Bulletin for SABRE Automotive Infotainment Touch Interrupt i.MX 6Quad and i.MX 6DualLite CPU Cards

by: Freescale Applications Engineering

Issue addressed is a touch interrupt path error.

1.1 Identification of Boards Requiring Field Rework

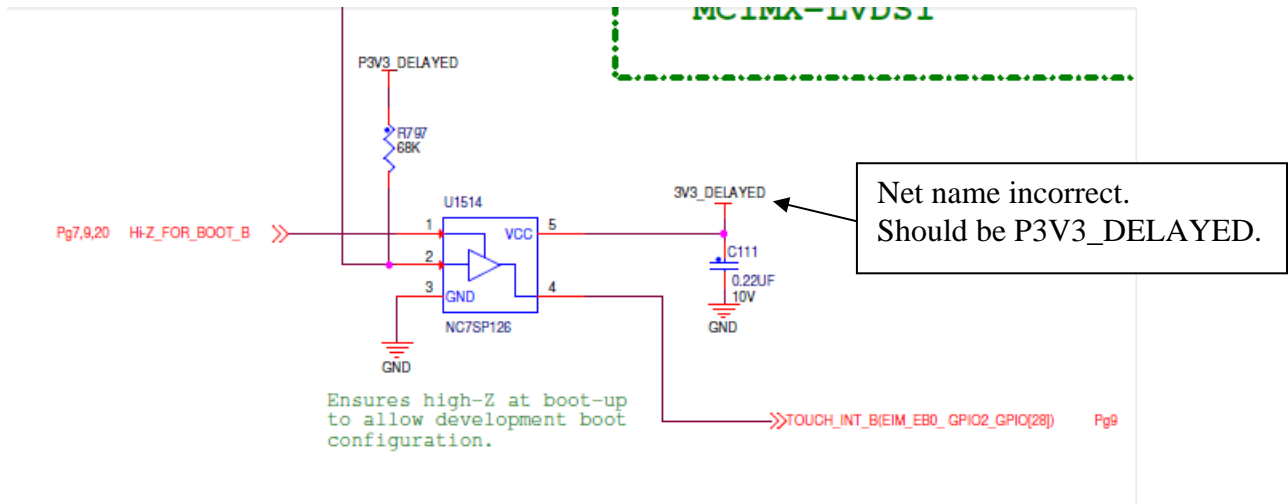
Rework is only needed for the few CPU Cards that do NOT have a TDA4451 sticker on the top side. For example, rework was completed on the board pictured below before shipping.

1.5 Board Rework Detail

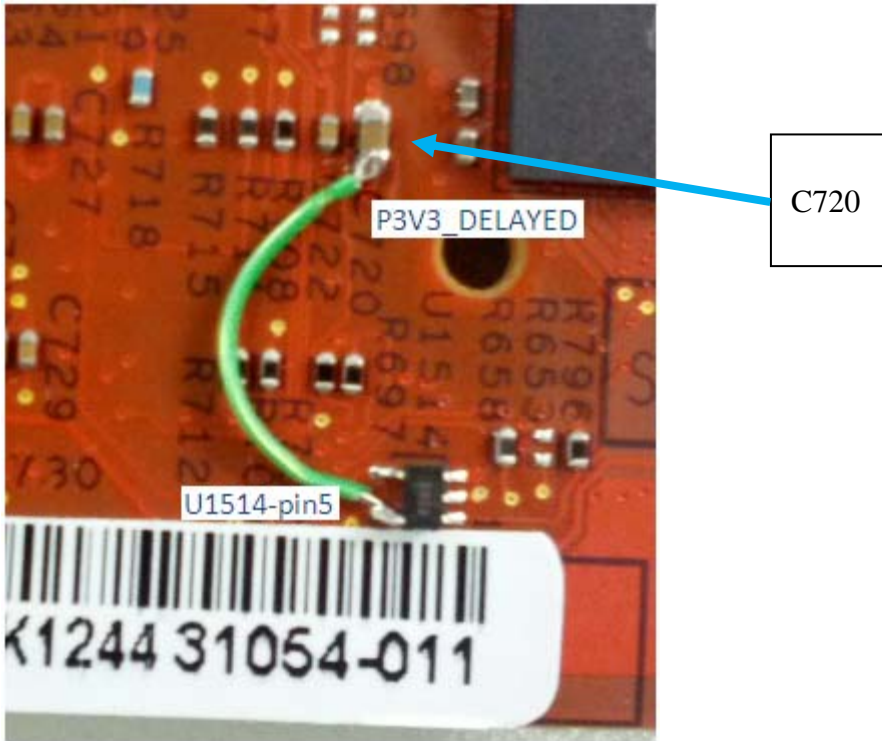
The processor never receives the LVDS touch panel interrupt. A buffer has its power pin unconnected.

Rework location is on the bottom of the board near the serial number sticker, as shown. Add the one wire.

Connect interrupt buffer U1514 pin 5 to power rail P3V3_DELAYED.

Boards with a TDA4451 sticker already have the rework with a very small gauge red or orange wire.
